Hybrid Assembly: MeltroniX

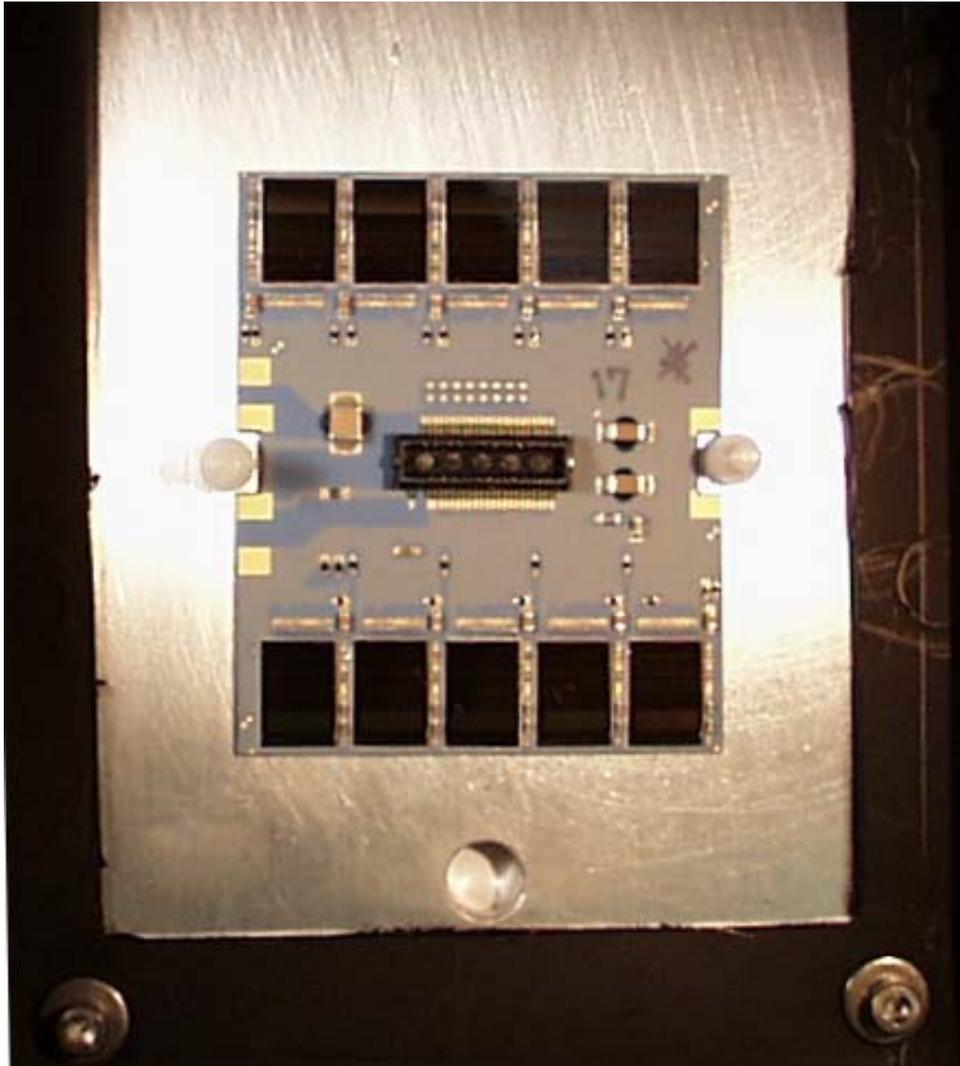
Used epoxy instead of solder for SMT

Unfortunately some bonds misplaced- (Problem identified: ambiguous drawing)

Otherwise workmanship is very good.
